GW - 52

**GENERAL  
CORRESPONDENCE**

RE: Sampling Plan for Water Wells Within Two Miles of the Site  
Transwestern Pipeline Company Roswell Compressor Station

**RE: Discharge Plan GW-52 Modifications  
Roswell Compressor Station No.9  
Chaves County, New Mexico**

**FIGURE 1**  
 ROSWELL SYSTEM SCHEMATIC  
 (N.T.S.)

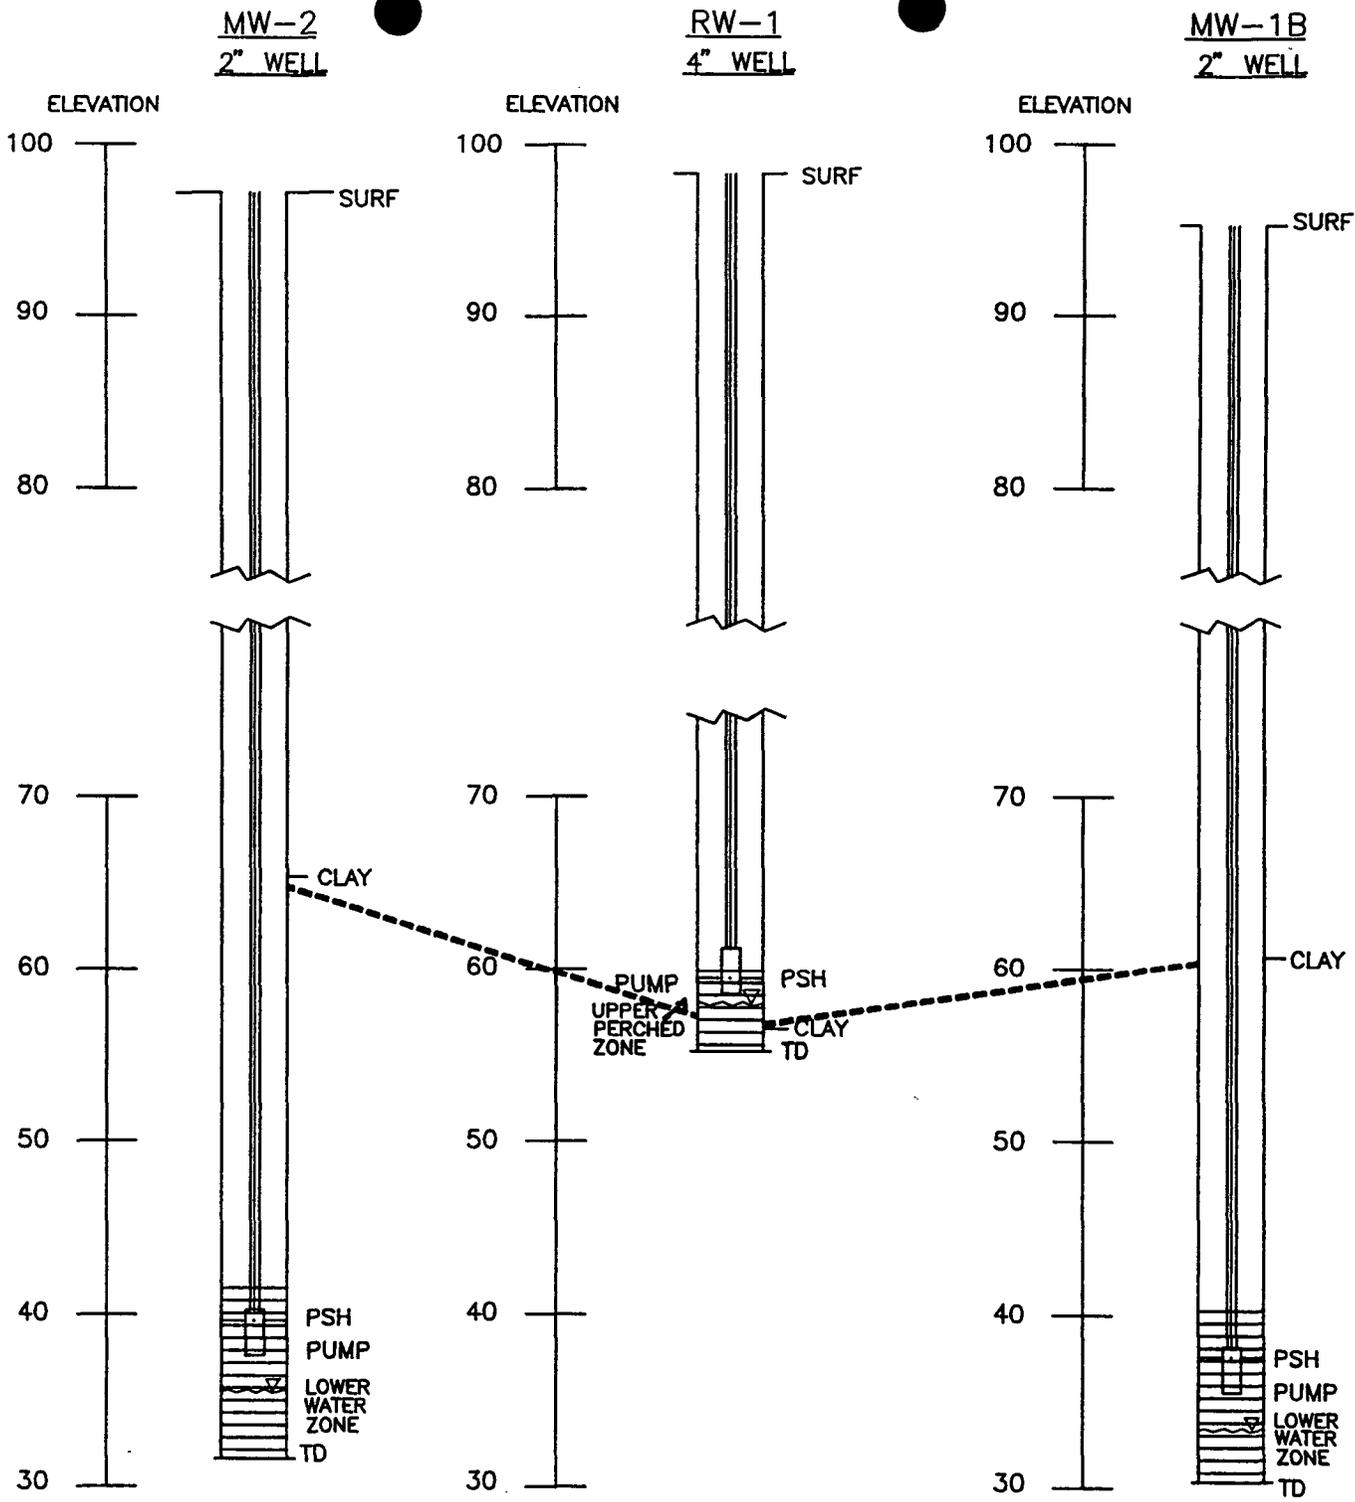
Brown and Root Environmental (B&R Environmental) completed the installation of a Phase Separated Hydrocarbon (PSH) recovery system at the Transwestern Pipeline Company's (Transwestern) Compressor Station No. 9 located in Roswell, New Mexico on July 1, 1993. Figure 1 shows the layout of the recovery system.
